STATE OF HAWAII DEPARTMENT OF TRANSPORTATION HIGHWAYS DIVISION

ADDENDUM NO. 1 FOR KUHIO HIGHWAY RESURFACING WAIKAEA BRIDGE TO MAILIHUNA ROAD FEDERAL-AID PROJECT NO. NH-056-1(063) DISTRICT OF KAWAIHAU ISLAND OF KAUAI April 21, 2023

NH-056-1(063)

Addendum No. 1 4/21/23

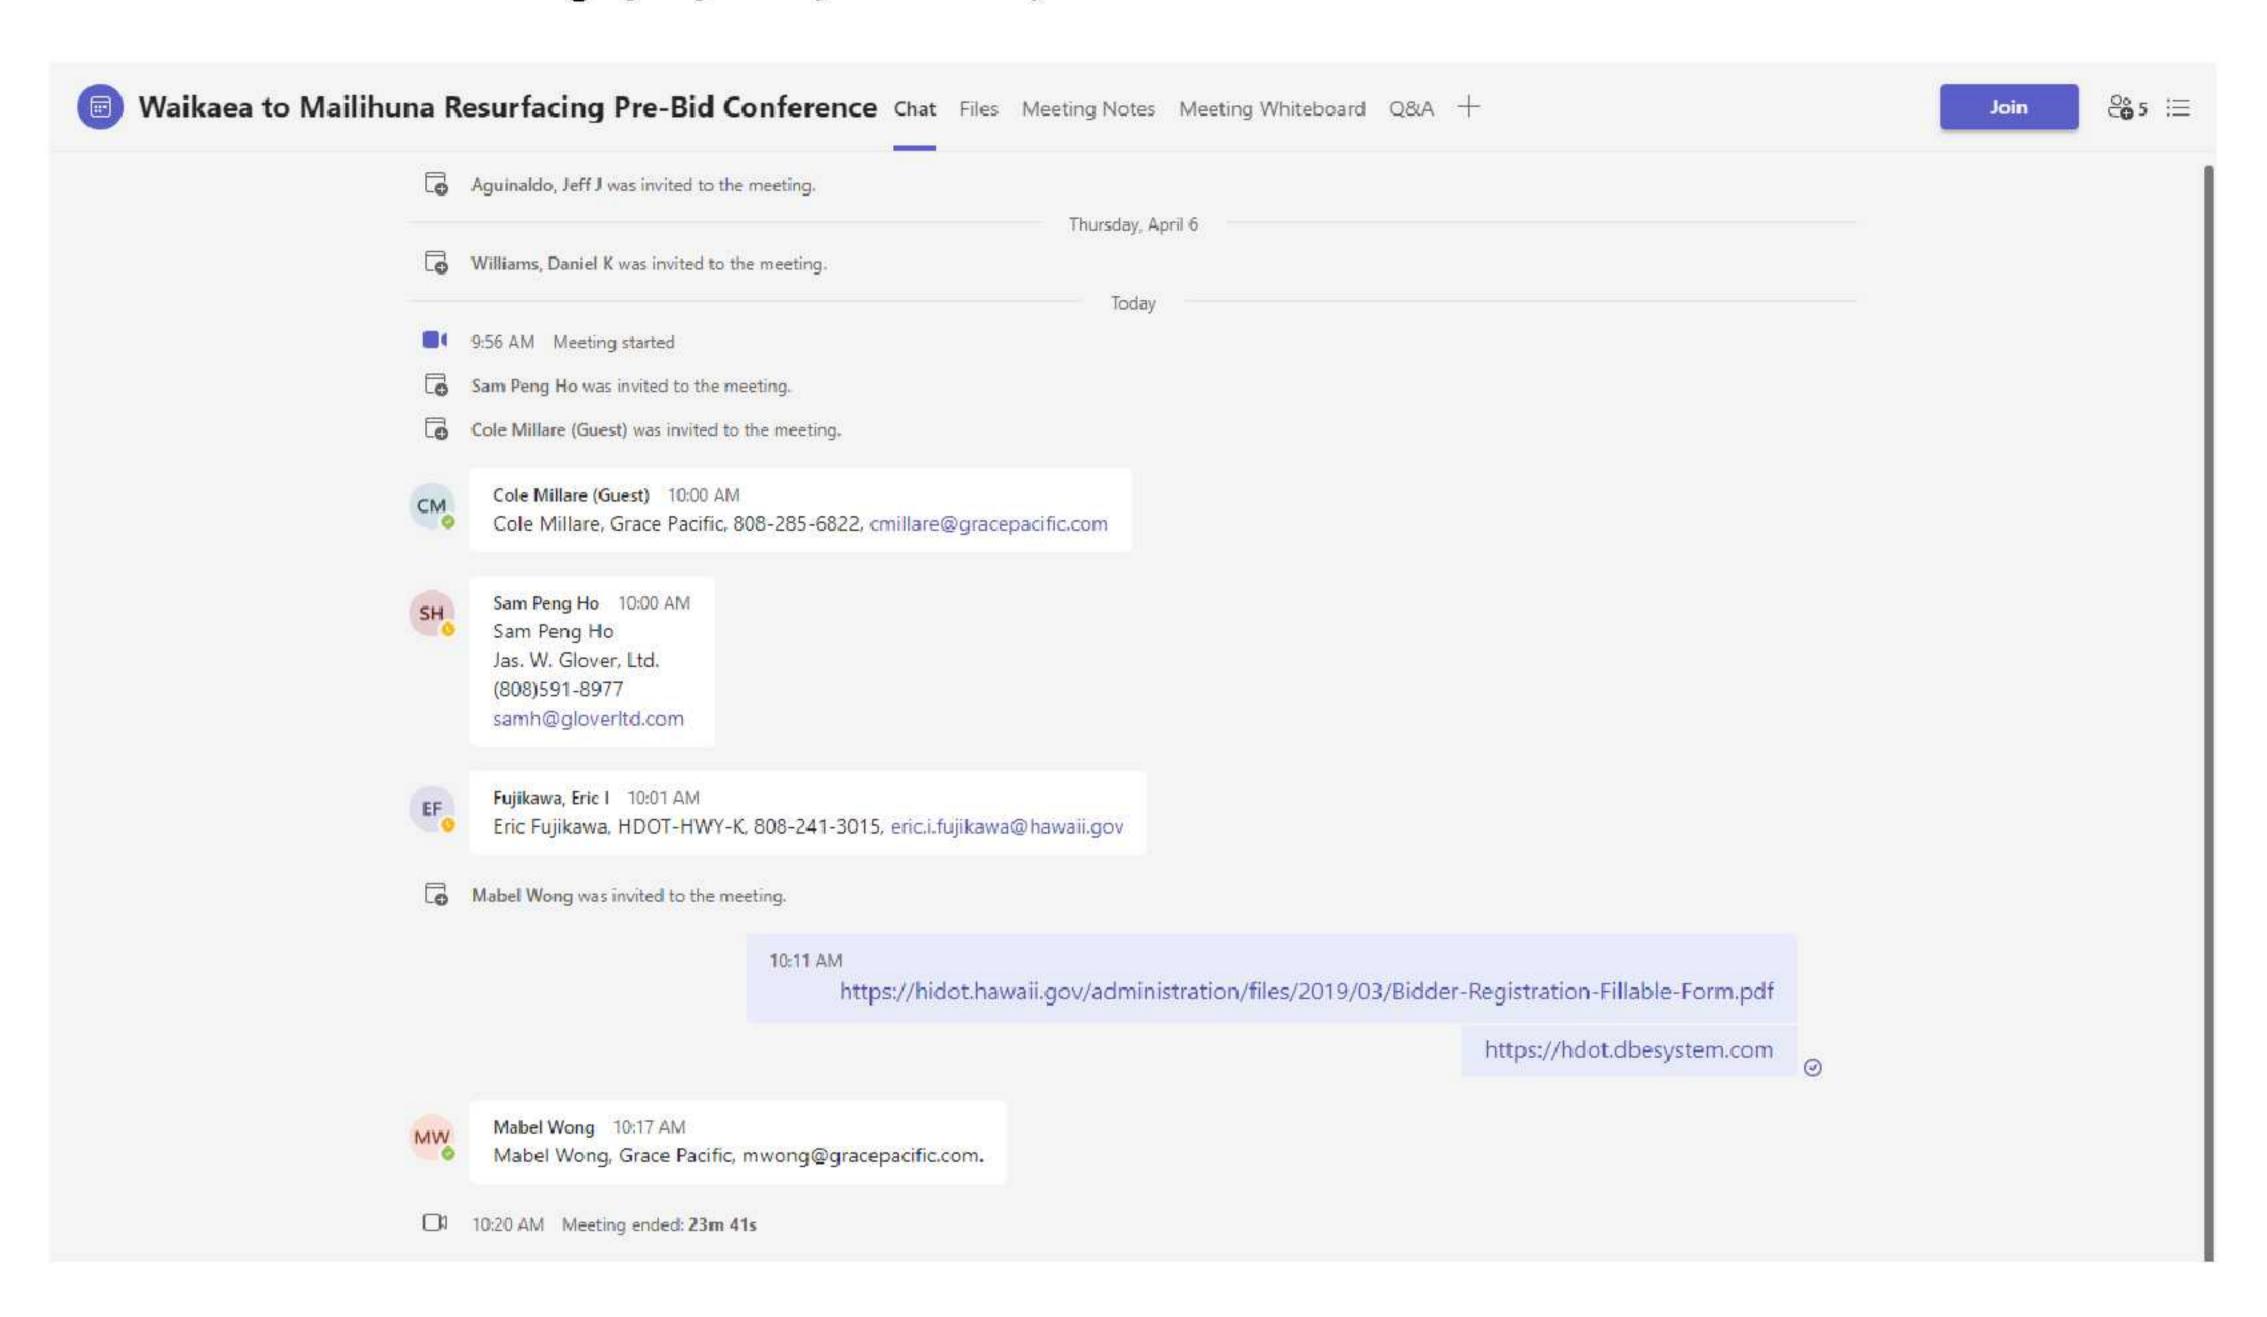
Questions #5: Please call out beginning and ending stations of AC Swale.

Response: We will clarify this in the addendum.
